# **TYPE II LAND DIVISION & ENVIRONMENTAL REVIEW,** STAFF REPORT & DECISION

TALBOT ESTATES

PLD2009-00017;

The applicant is requesting to short plat 19.8 acres into two single-family residential lots located in the R-10 zone district.

Copy of Proposed Preliminary Plan

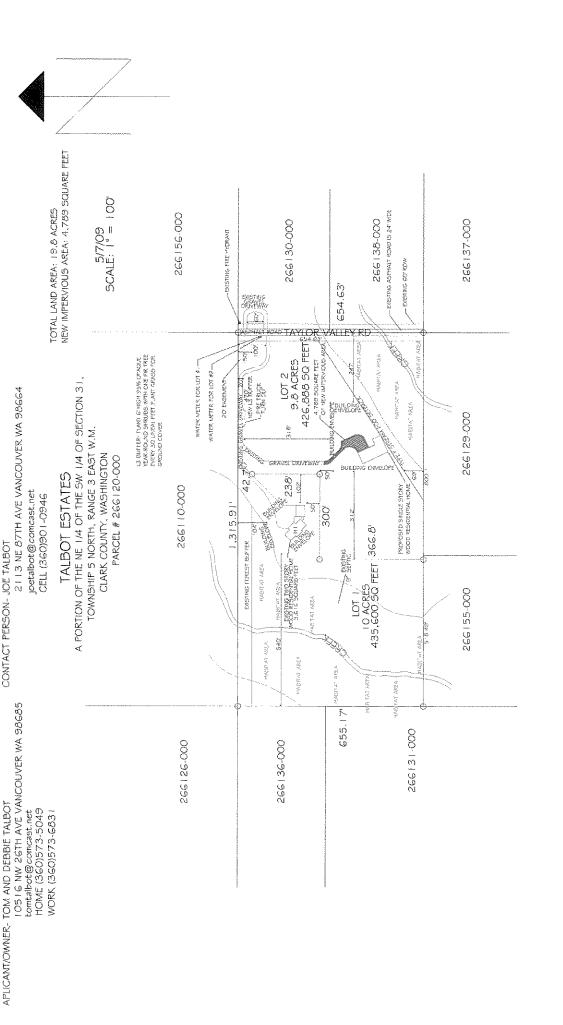
The lot width is measured at the building setback line. The front lot line is that from which access is taken. The proposal complies with the lot area standards but lot 1 does not comply with the lot width standards as it is about 280 feet in width along the line where access is taken (east line) and the home is located. That can be easily revised so that the lot will meet the lot width standard. (See Condition D-2)

The preliminary plat map shows a 50 foot wide area to be used for the landscaping and a note stating what vegetation the L-3 landscape requires, but no landscape plan. Per CCC 40.510.050-1, a landscape plan must contain the following information: species of plants, location, number, size at time of planting and spacing of the proposed plant materials. A landscape plan meeting those requirements will need to be submitted and approved and the landscaping planted prior to final plat approval. (See Conditions D-3 and D-4)

- **D-1** One lot shall be a minimum of 10 acres. (See Land Use Finding 1)
- D-2 The front (east) lot line of proposed lot 1 shall be widened to 330 feet and this width shall be constant for the area within the building envelope. (See Land Use Finding 1)

- **D-3** A landscape plan as described in land use finding 2 and required by CCC 40.510.050-1 shall be submitted and approved. (See Land Use Finding 2)
- D-4 Verification of the Installation of Landscape
